1997 - 1998 Corvette: Service Bulletin: Front Fender to Door Fit/Appearance (Install Retainer)

Subject: FRONT FENDER TO DOOR FIT/APPEARANCE (INSTALL RETAINER)

Number: 83-15-13 - (07/17/1998)

Models: 1997-1998 Chevrolet Corvette

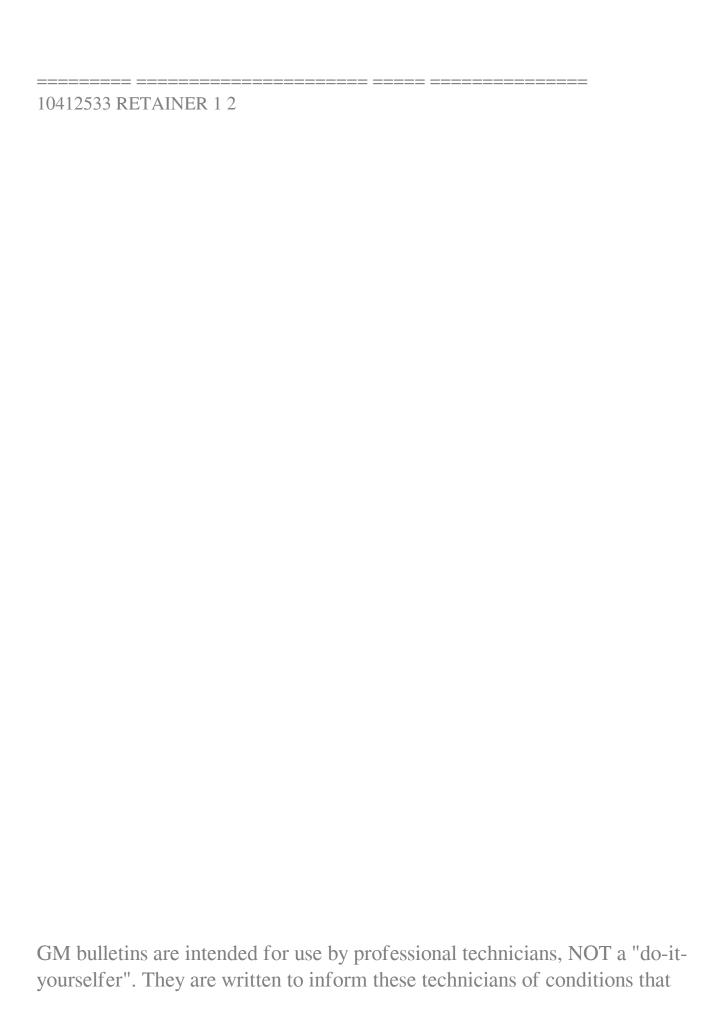
SOME OWNERS MAY COMMENT THAT THE REAR UPPER CORNER OF THE DRIVER'S AND/OR PASSENGER'S FRONT FENDER DOES NOT FIT WELL WITH THE FRONT UPPER EDGE OF THE DOOR (SEE FIGURE 1). THEY MAY ALSO COMMENT THAT THE CONDITION APPEARS MORE NOTICEABLE WHEN THE VEHICLE IS EXPOSED TO WARMER AMBIENT TEMPERATURES.

THIS CONDITION MAY OCCUR ON SOME VEHICLES WHEN THE OUTIDE TEMPERATURE IS HIGH AND THE VEHICLE HAS BEEN IN DIRECT SUNLIGHT FOR MORE THAN TWO HOURS. DURING THESE CONDITIONS, THE FRONT FENDER MATERIAL, WHICH IS ABSORBING HEAT ENERGY, MAY BEGIN TO "DROOP" SLIGHTLY AT THE UPPER REAR CORNER. WHEN THIS OCCURS, THE UPPER REAR EDGE OF THE FENDER MAY NOT APPEAR FLUSH TO THE FRONT UPPER DOOR EDGE. AS THE FENDER COOLS, IT RETURNS TO ITS ORIGINAL FIT OR FLUSHNESS.

TO CORRECT THIS CONDITION, INSTALL ONE RETAINER (P/N 10412533) TO THE UPPER FRONT EDGE OF BOTH DOORS AS SHOWN IN FIGURE 1.
